May 9, 2002

SUBJECT: SUMMARY OF APRIL 24, 2002, MEETING WITH NUCLEAR ENERGY
INSTITUTE ON TOPICS RELATED TO THE EMERGENCY
PREPAREDNESS CORNERSTONE OF THE REACTOR OVERSIGHT
PROCESS

PUBLICLY OBSERVED MEETING ON TOPICS RELATED TO THE
EMERGENCY PREPAREDNESS CORNERSTONE
OF THE REACTOR OVERSIGHT PROCESS
APRIL 24, 2002
ONE WHITE FLINT NORTH
O-13-B4

**Proposed Revision to EP SDP
 Failure to meet Regulatory Requirement
 (This line replaces left line sheet 1 Failure to meet Regulatory Requirement)**

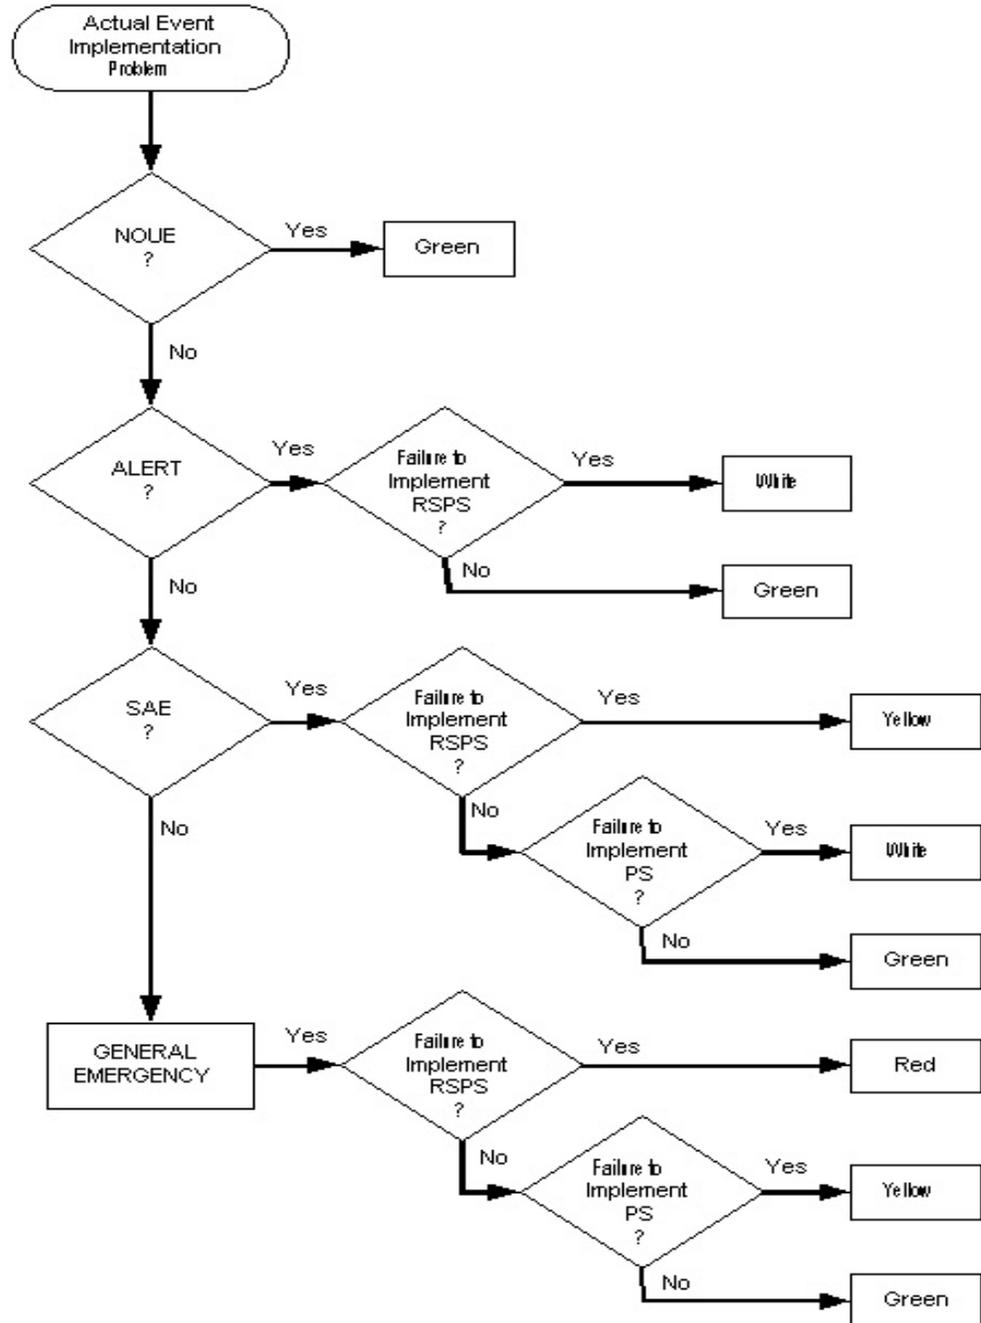
NEI provided definitions (Attachment 5) for 3 key terms used in the EP SDP document. These included the words function, degraded, and judgment. NEI presented a draft flowchart for the SDP non-compliance branch (Attachment 6). The staff discussed the incorporation of numerous references and examples and, in some instances, numerical parameters, to better define a planning standard function as being classified as met, degraded, or a loss.
